PROPOSED WAREHOUSE

PROPOSED LOT 505 on SP316171 301 Coastlink Court, Stapylton

LANDSCAPE PLANS APPROVED

Application No.: OPW/2025/1127

Drawing No: L-PRI-PP01 Rev. No: 3

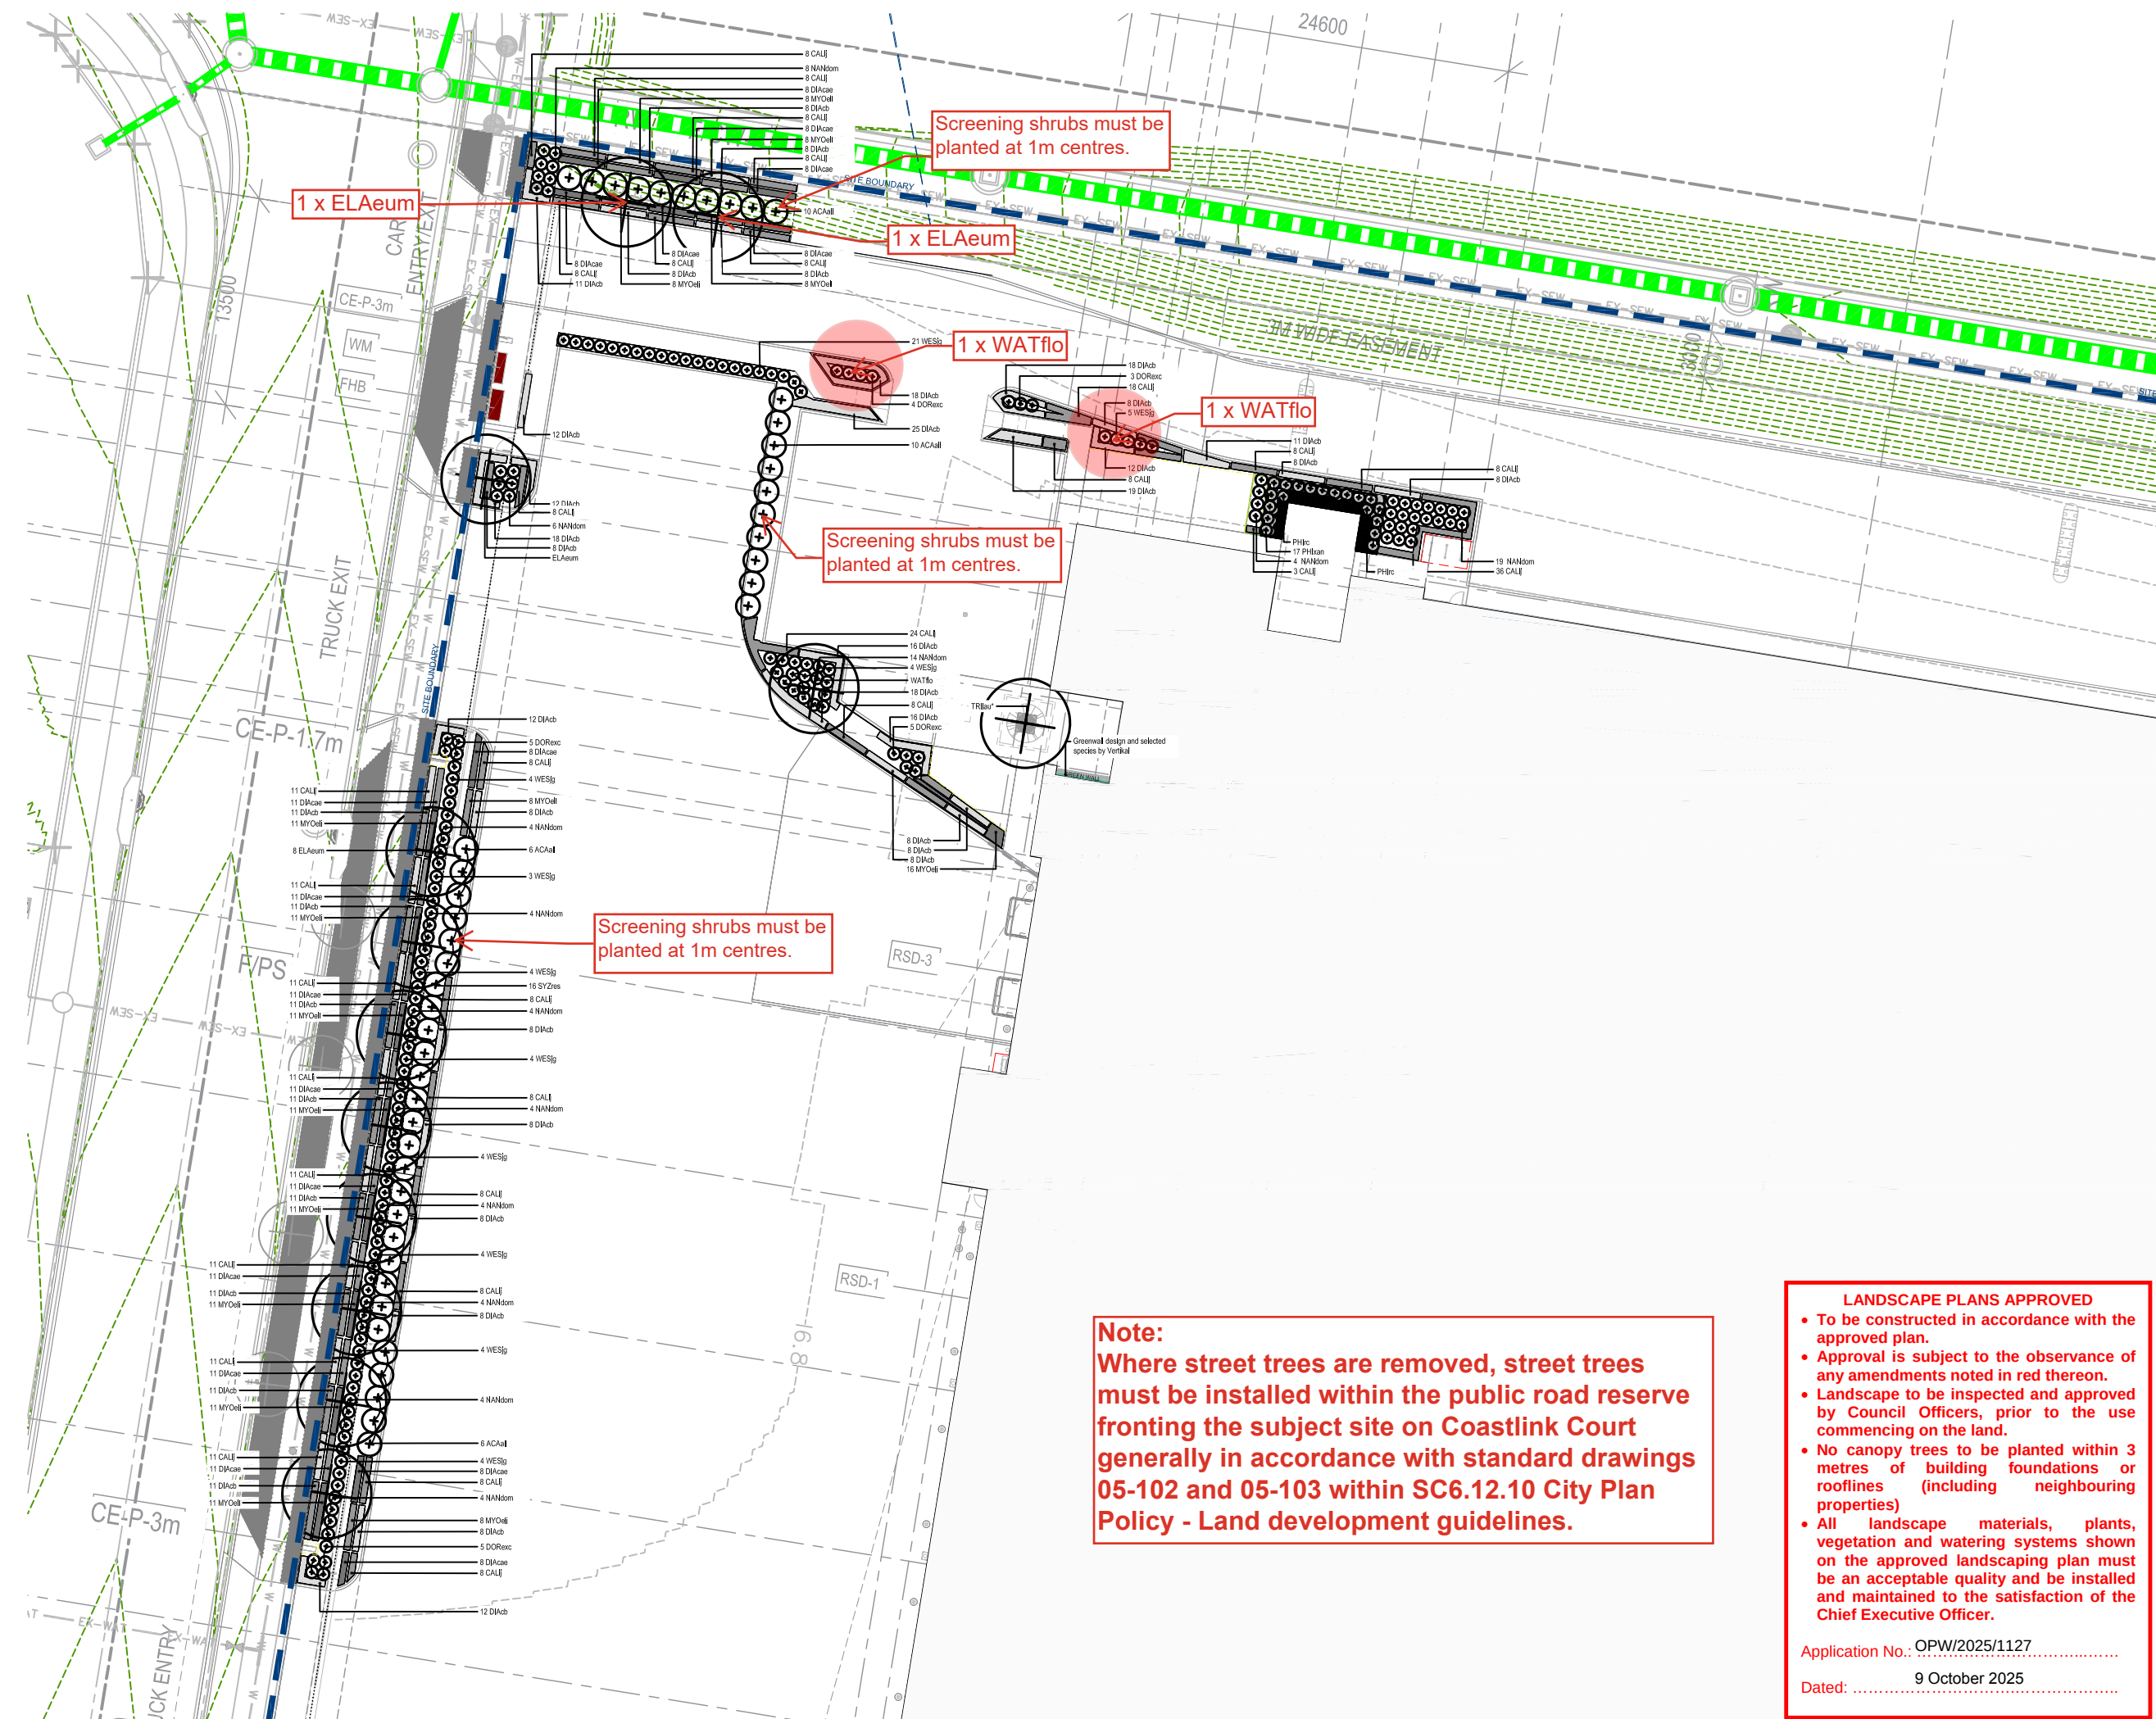
Note:
Where street trees are removed, street trees must be installed within the public road reserve fronting the subject site on Coastlink Court generally in accordance with standard drawings 05-102 and 05-103 within SC6.12.10 City Plan Policy - Land development guidelines.

Drawing No:
L-PRI-PP02

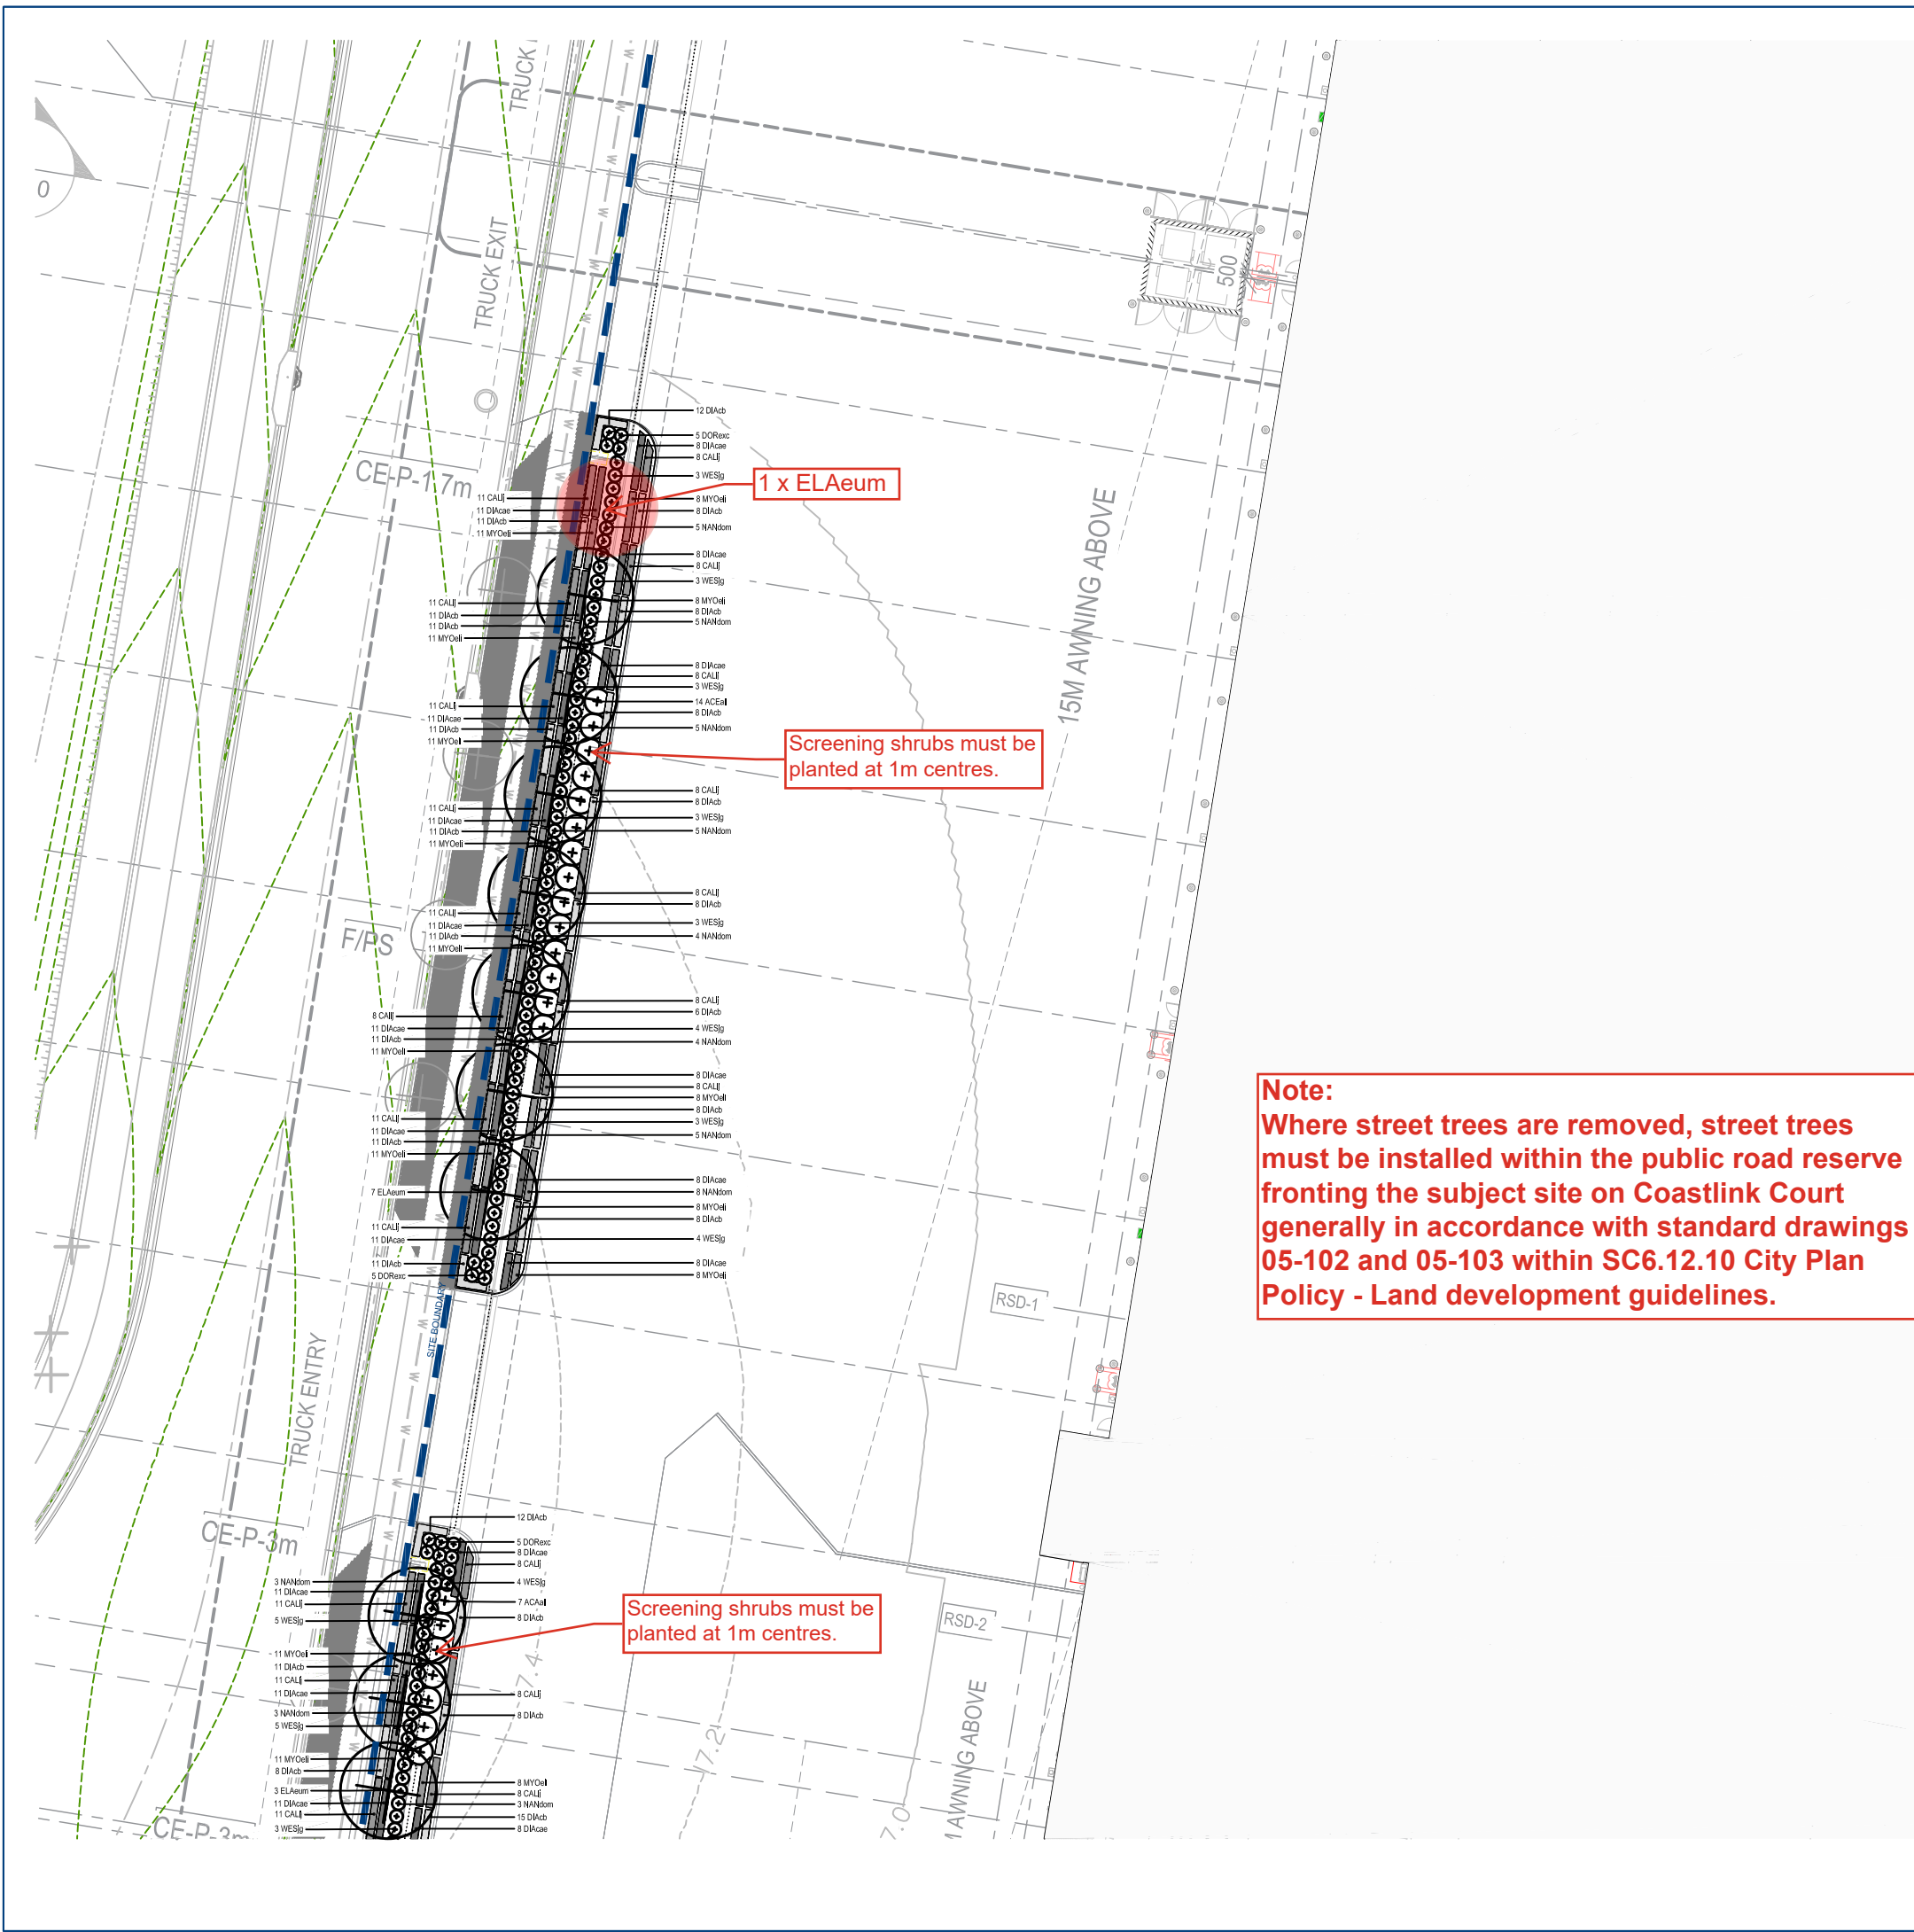
Note:
Where street trees are removed, street trees must be installed within the public road reserve fronting the subject site on Coastlink Court generally in accordance with standard drawings 05-102 and 05-103 within SC6.12.10 City Plan Policy - Land development guidelines.

Drawing No:	Rev. No:
PRI-PP05	3

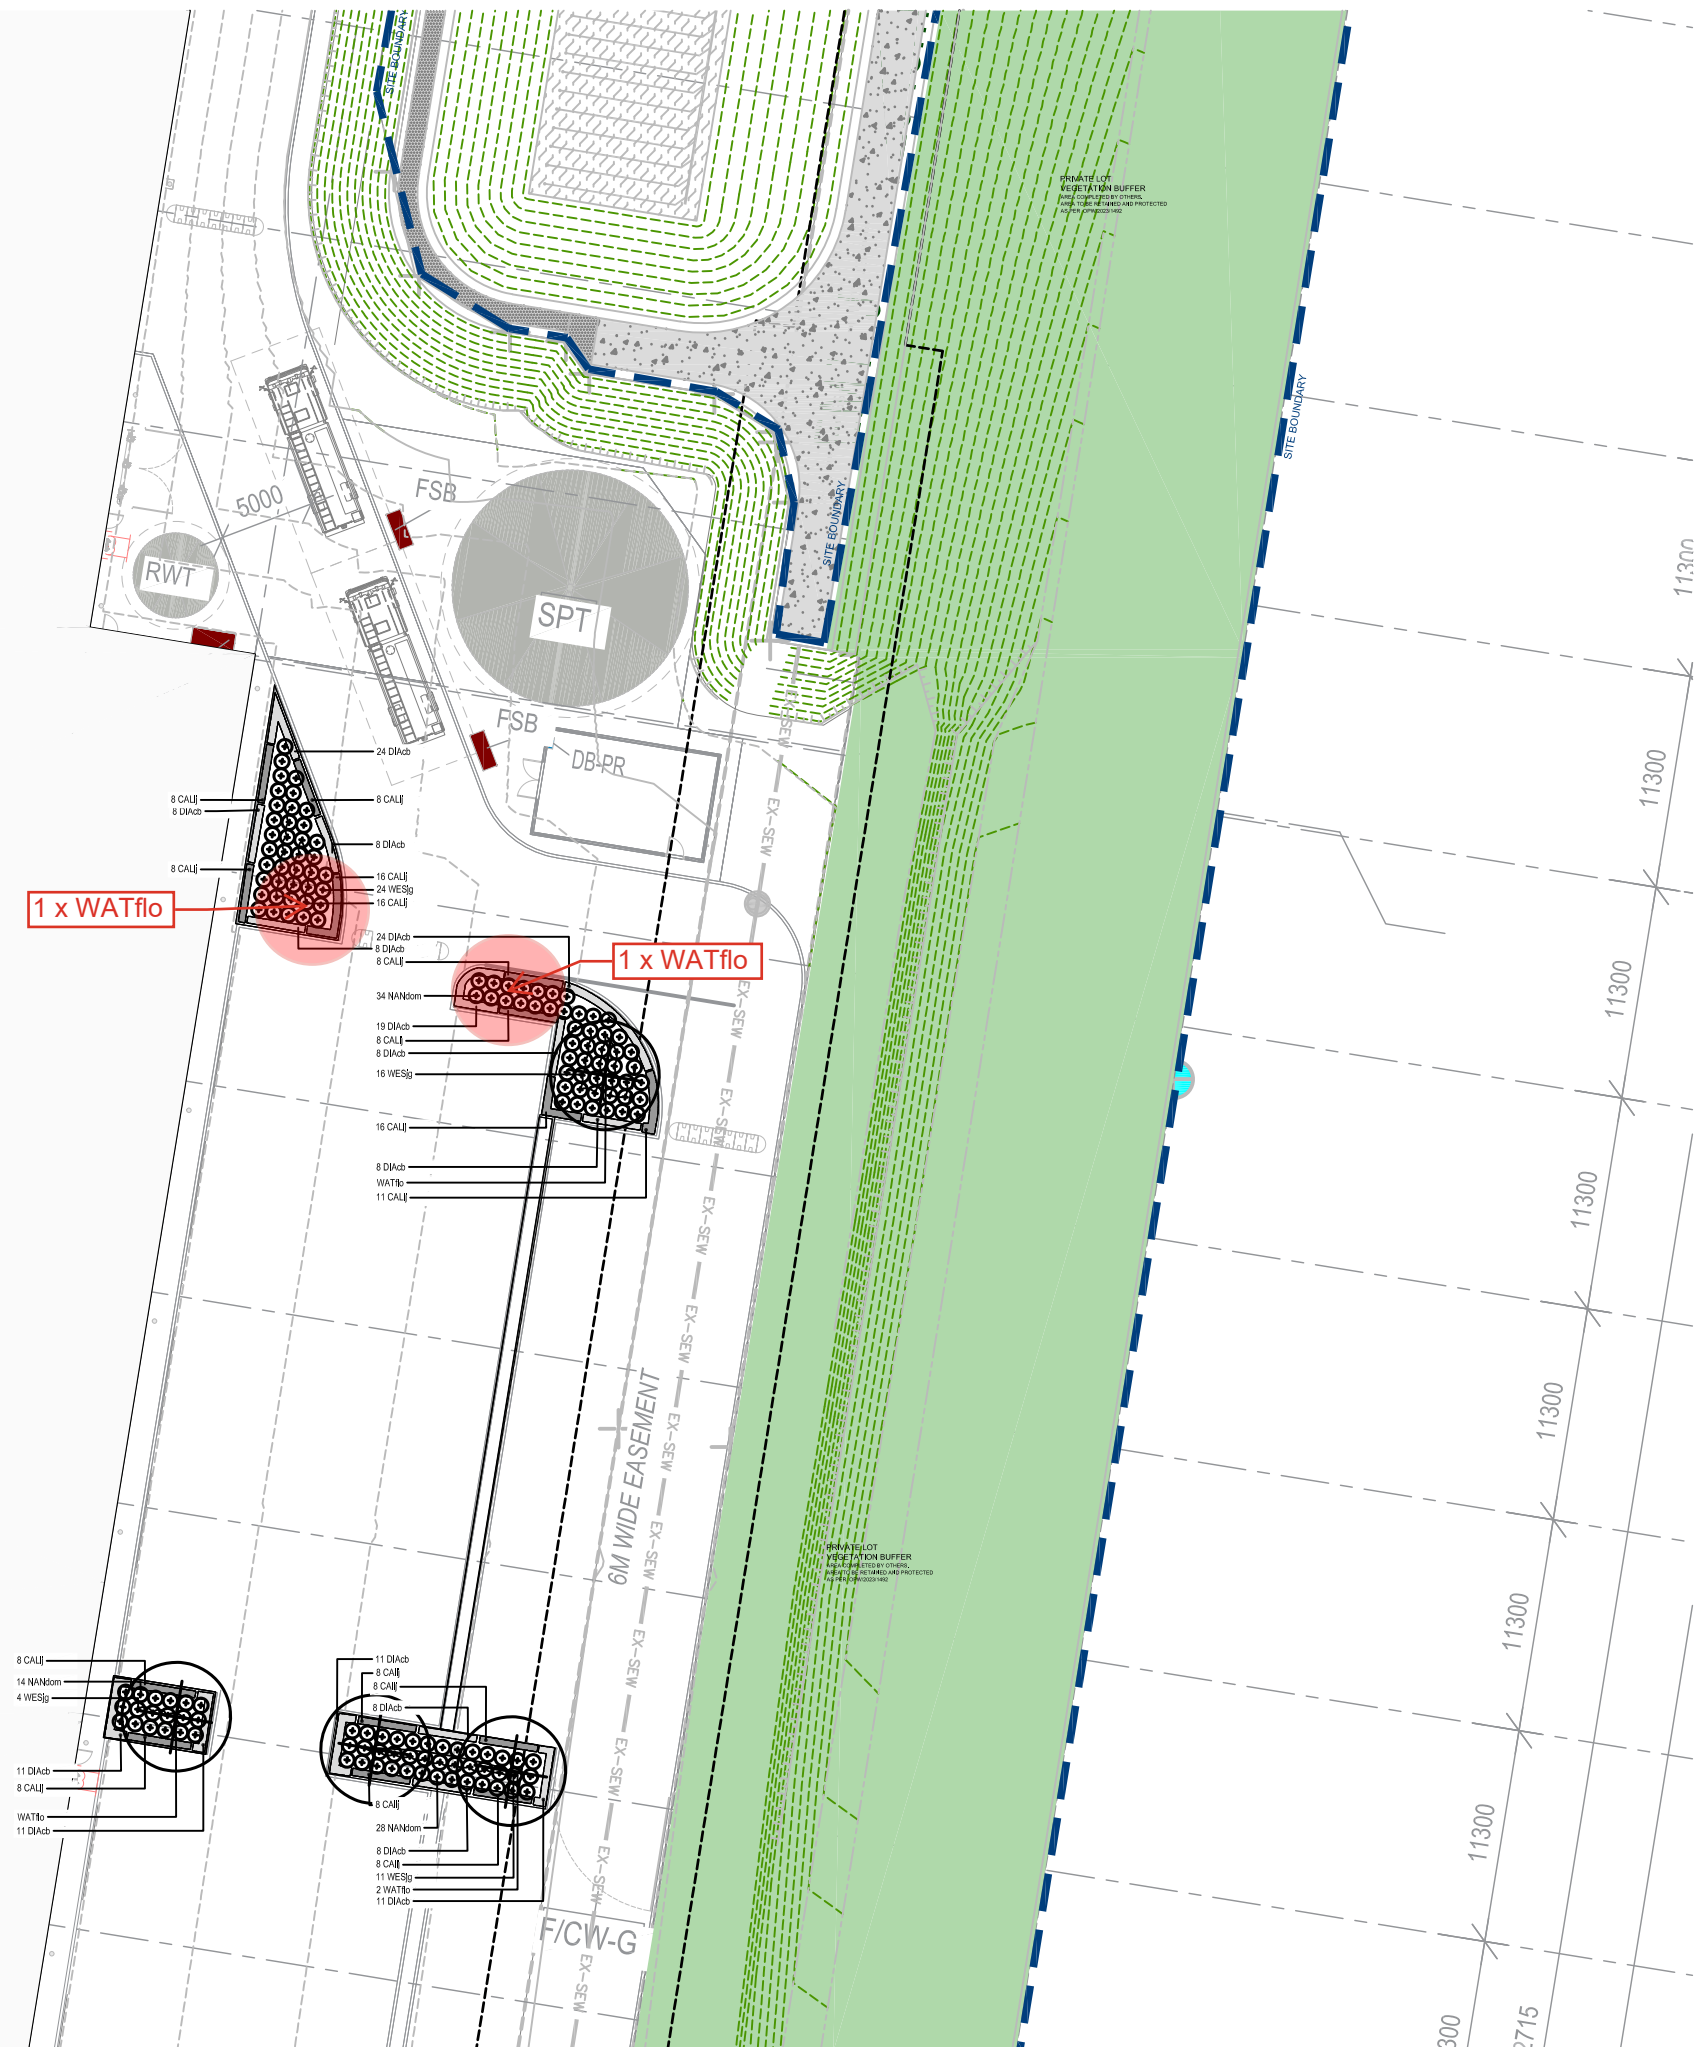
1 x WATflo

1 x WATflo

Screening shrubs must be planted at 1m centres.

Note: Where street trees are removed, street trees must be installed within the public road reserve fronting the subject site on Coastlink Court generally in accordance with standard drawings
